CITY OF PENSACOLA, FLORIDA
ADDENDUM #1
TO THE INVITATION TO BID

PORT OF PENSACOLA WAREHOUSE REPAIRS

BID NO: 21-040

CLIENT DWG NO:
WAREHOUSE REPAIRS PROJECT
WAREHOUSE #5 ELECTRICAL SINGLE LINE,
RISER DIAGRAM AND CABLE SCHEDULE
 FOR: THE PORT OF PENSACOLA
 PROJECT NO: 4474 DWG NO: E3 REV: B

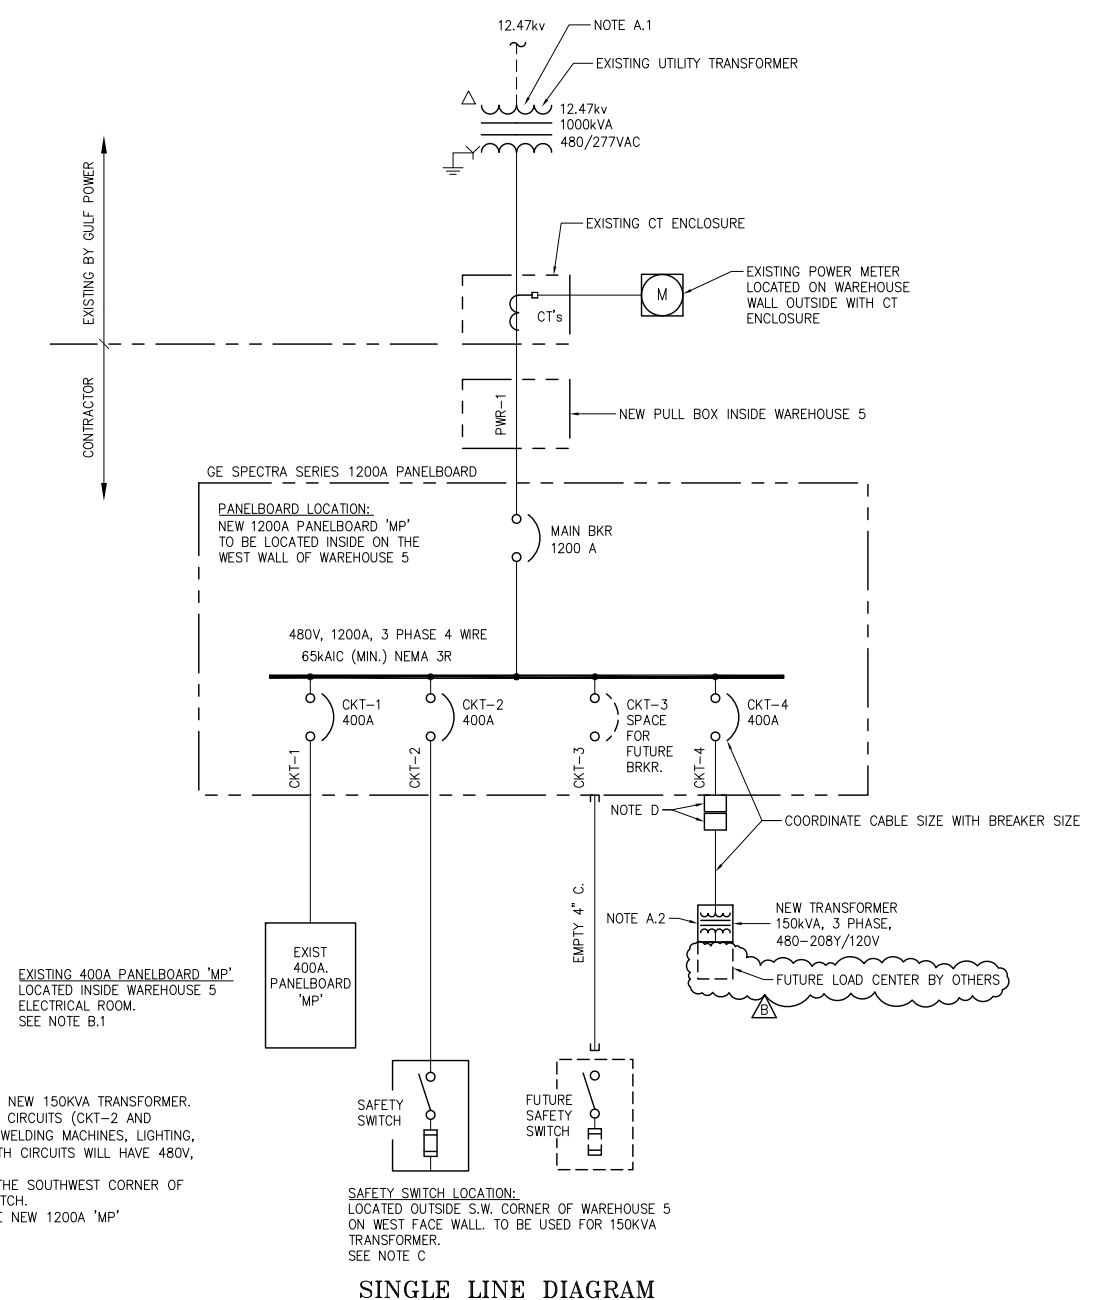
4. Please provide more info on the load center off the new transformer if possible (amperage, main breaker or lug, NEMA rating, branch breakers)?
The new transformer is replacing a previous transformer which was damaged due to Hurricane Sally. The new transformer will be used for a future shore power project. See revision B of drawing E3.

- THERE ARE TWO EXISTING MAIN PANELBOARDS DESIGNATED AS 'MP'.
 - 1200A MAIN PANELBOARD 'MP' LOCATED OUTSIDE ON THE WEST WALL.
 - 400A MAIN PANELBOARD 'MP' LOCATED INSIDE IN THE ELECTRICAL ROOM.

- ALL EXISTING EQUIPMENT ON THE OUTSIDE OF WAREHOUSE 5 TO BE REMOVED EXCEPT FOR THE 'CT' ENCLOSURE.
- NEW 1200A MAIN PANELBOARD 'MP' FEEDERS:**
 - THE CABLES FROM THE 'CT' ENCLOSURE TO THE EXISTING 1200A MAIN PANELBOARD 'MP' SHALL BE DISCONNECTED FROM THE 1200A MAIN PANELBOARD 'MP' AND PULLED BACK TO THE 'CT' ENCLOSURE SO THAT THE CABLES CAN BE REROUTED INTO WAREHOUSE 5 TO THE NEW 1200A MAIN PANELBOARD 'MP' LOCATION. **DO NOT CUT THE CABLES BEFORE REROUTING TO ASSURE THAT THERE IS ENOUGH LENGTH ON THE CABLES TO REACH THE NEW 1200A MAIN PANELBOARD 'MP' LOCATION AND TERMINATE.**

- FEEDER CABLES SHALL BE REPLACED NEW IF FOUND TO BE DAMAGED.
- EXISTING 400A MAIN PANELBOARD 'MP' FEEDERS:**
 - EXISTING FEEDER CABLE FROM THE EXISTING 1200A MAIN PANELBOARD 'MP' TO THE EXISTING 400A MAIN PANELBOARD 'MP' DISCONNECT SWITCH LOCATED ON THE OUTSIDE WALL OF WAREHOUSE 5 TO BE DISCONNECTED AND PULLED OUT OF THE EXISTING CONDUITS FOR RE-USE INSIDE WAREHOUSE 5 TO RECONNECT THE NEW 1200A MAIN PANELBOARD 'MP' TO THE EXISTING 400A MAIN PANELBOARD 'MP'. **DO NOT CUT THE CABLES BEFORE REROUTING TO ASSURE THAT THERE IS ENOUGH LENGTH ON THE CABLES TO RECONNECT THE EXISTING 400A MAIN PANELBOARD 'MP' TO THE NEW 1200A MAIN PANELBOARD 'MP'.**

- FEEDER CABLES SHALL BE REPLACED NEW IF FOUND TO BE DAMAGED.
- EXISTING 150KVA TRANSFORMER** WILL BE REPLACED WITH A NEW 150KVA TRANSFORMER. THE NEW 150KVA TRANSFORMER WILL HAVE TWO AVAILABLE CIRCUITS (CKT-2 AND CKT-4) TO SERVE THE TRANSFORMER AND OTHER LOADS (WELDING MACHINES, LIGHTING, ETC.) FROM THE NEW 1200A MAIN PANELBOARD 'MP'. BOTH CIRCUITS WILL HAVE 480V, THREE PHASE, 400A RECEPTACLES AVAILABLE AS FOLLOWS:

- CKT-2 WILL BE LOCATED OUTSIDE WAREHOUSE 5 ON THE SOUTHWEST CORNER OF THE WAREHOUSE AT THE NEW SAFETY DISCONNECT SWITCH.
 - CKT-4 WILL BE LOCATED INSIDE WAREHOUSE 5 AT THE NEW 1200A 'MP' PANELBOARD.
